WHEREAS, the City Plan and Zoning Commission has advised that at a public hearing held on September 19, 2013, its members voted 10-0 in support of a motion to recommend **APPROVAL** of a request from Youth Emergency Services (owner) represented by Stephen Quirk (officer) for the vacation of the north 20 feet of Railroad Avenue south of and adjoining the subject property located at 918 Southeast 11<sup>th</sup> Street subject to retention of easements or relocation by the owner of any public utilities in place.

Communication from the City Plan and Zoning Commission advising that at their meeting held September 19, 2013, the following action was taken regarding a request from Youth Emergency Services (owner) represented by Stephen Quirk (officer) for the following action related to rezoning of property located at 918 Southeast 11<sup>th</sup> Street.

Youth Emergency Shelter Service - 918 SE 11th Street

**CONCEPTUAL PUD PLAN  
 YOUTH EMERGENCY SHELTER  
 SERVICE**

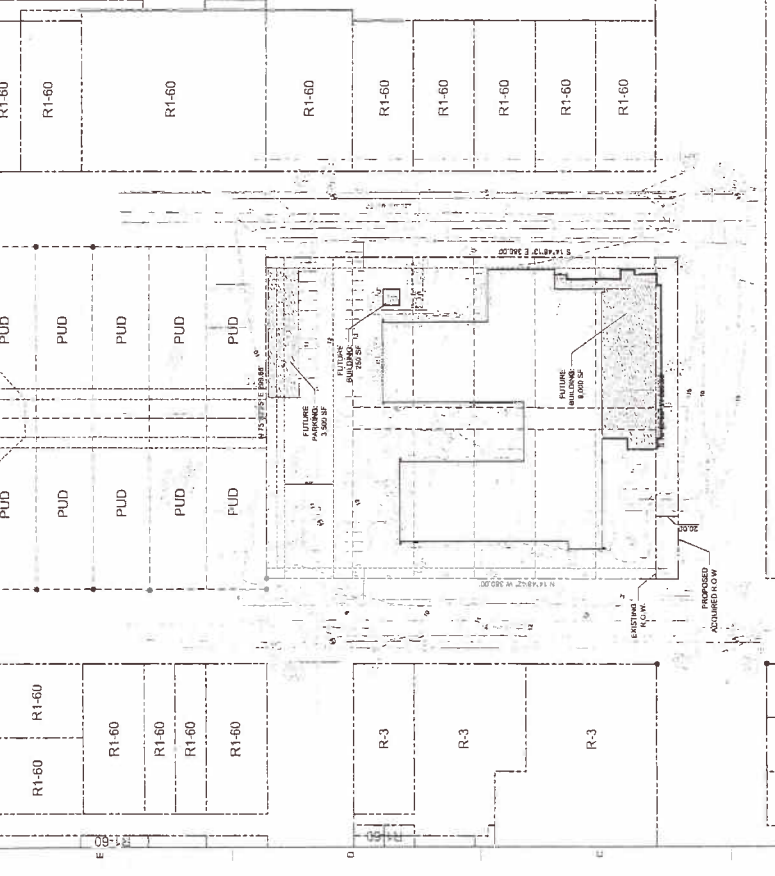
- 1) Addition of a note that any Development Plan shall comply with all Tree Preservation and Mitigation Ordinances.
- 2) Revision of the stormwater management statement to reflect compliance with the minimum requirements in the City's Site Plan policies.
- 3) Indication of conceptual location(s) for storm water management features.

- 4) Restoration of the Southeast 11<sup>th</sup> Street right-of-way to remove encroachment of off-street parking in addition to providing a minimum five-foot off-street parking setback with a three-foot landscape screen on both Southeast 10<sup>th</sup> Street and Southeast 11<sup>th</sup> Street.

- 5) Provision of minimum bufferyard requirements as applicable to "R-3" Districts as part of any future off-street parking extension.
- 6) Relocation of the public sidewalk to the south shall be shown based on the displacement by proposed building addition.

- 7) Revision of the parking standards to define parking requirements as they are required for shelters for the homeless contained in Section 134-1377(a)(30).

- 8) Provision of a note requiring architectural screening of any roof top mechanical units as part of any building addition.
- 9) Provision of fencing details for all site fencing to be permitted.

There is currently not any designed detention for the existing site. The statement in the proposed plan implies that no stormwater management would be provided until a threshold of 83,000 square feet of impervious surface is attained. This is approximately 16,000 square feet more than the existing condition. Stormwater management requirements are required at 10,000 square feet of new impervious surface. This

No bufferyard requirements are proposed from adjoining residential development to the north. The existing parking lot also has portions with nearly a zero setback from the residential PUD to the north. The Conceptual Plan proposes a future parking expansion that would remove any existing setback. Staff believes that the bufferyard requirement should be maintained for any future expansion of off-street parking.

The existing zoning conditions require three-foot screening of the parking lot from Southeast 10<sup>th</sup> Street and Southeast 11<sup>th</sup> Street. This is not currently in place. There is also not a minimum required five foot setback on the Southeast 11<sup>th</sup> Street side. The parking is currently paved with an encroachment into the public right-of-way. This was restored recently to the previous condition as part of a WRA sanitary sewer project. Staff believes that this should be restored at a minimum with the five-foot setback and a three foot landscape screen from Southeast 11<sup>th</sup> Street should be provided as well. This would cause the loss of around four existing parking spaces.

The current property has a fenced outdoor playground area. The proposed plan does not indicate any plan to shift or move this to another location. Should there be any plan to do this, it must be defined on the Conceptual Plan with details for fence material, height, and location.

5. **Streets/Sidewalk:** The proposed expansion of the shelter is not anticipated to generate enough additional traffic to require any improvements to the surrounding street network. The applicant proposes to vacate the north 20 feet of Railroad Avenue adjoining the subject property. Railroad Avenue has a wide right-of-way with an asphalt paved rural cross-section in this location. Traffic Engineering and Public Works Staff have determined that the requested right-of-way is not necessary for a public purpose. However, the existing public sidewalk on the north side of the street will have to be reconstructed further south to accommodate the proposed addition. This needs to be reflected on the proposed Conceptual Plan.
